**SUNDRY NOTICES AND REPORTS ON WELLS**  
*Do not use this form for proposals to drill or to re-enter an abandoned well. Use form 3160-3 (APD) for such proposals.*

1. Type of Well <input checked="" type="checkbox"/> Oil Well <input type="checkbox"/> Gas Well <input type="checkbox"/> Other		8. Well Name and No. DIAMOND 31 FED COM 4H
2. Name of Operator EOG RESOURCES, INC.		9. API Well No. 30-025-00000 40986
3a. Address P.O. BOX 2267 MIDLAND, TX 79702	3b. Phone No (include area code) Ph: 432-686-3689	10. Field and Pool, or Exploratory RED HILLS Lower Bone Spring
4. Location of Well (Footage, Sec., T., R., M., or Survey Description) Sec 31 T24S R34E NENW 280FNL 2188FWL		11. County or Parish, and State LEA COUNTY, NM

EOG Resources requests an amendment to our APD for this well to reflect a change in casing.

**EOG RESOURCES, INC.**  
**DIAMOND 31 FED COM NO. 4H**  
**REVISED 3/27/12**

Diamond 31 Fed Com #4H  
Pitchfork Ranch  
Lea County, New Mexico  
Revised 3/27/12  
Proposed Wellbore

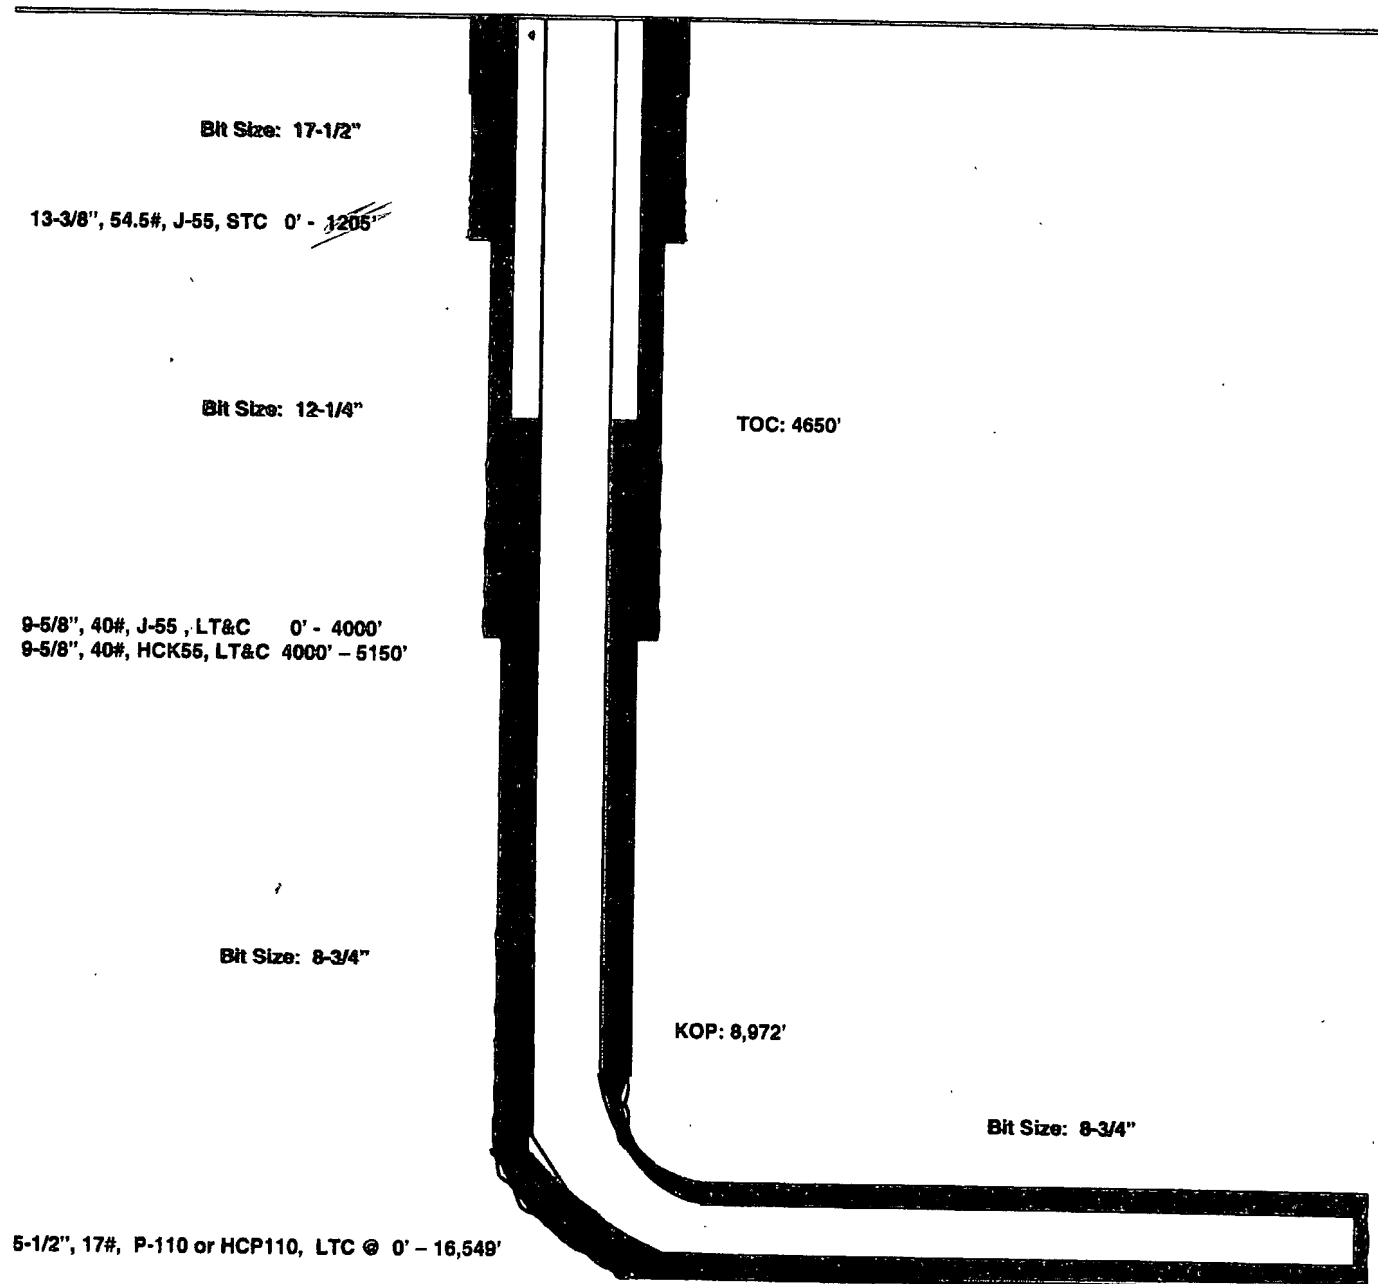
Casing changes are as follows:

From 11-3/4", 43#, H40 STC to 13-3/8", 54.5#, J55 STC  
From 8-5/8", 32#, J55/HCK55 LTC to 9-5/8", 40#, J55/HCK55 LTC  
From 5-1/2", 20#, HCP110 NSCC to 5-1/2", 17#, P110 or HCP110 LTC

Hole Size	Interval	Csg OD	Weight	Grade	Conn	DF <sub>min</sub> Collapse	DF <sub>min</sub> Burst	DF <sub>min</sub> Tension
17.5"	0 - 1205'	13.375"	54.5#	J55	STC	1.125	1.25	1.60
12.25"	0 - 4000'	9.625"	40#	J55	LTC	1.125	1.25	1.60
12.25"	4000'-5150'	9.625"	40#	HCK55	LTC	1.125	1.25	1.60
8.75"	0'-16,549'	5.5"	17#	P110 or HCP110	LTC	1.125	1.25	1.60
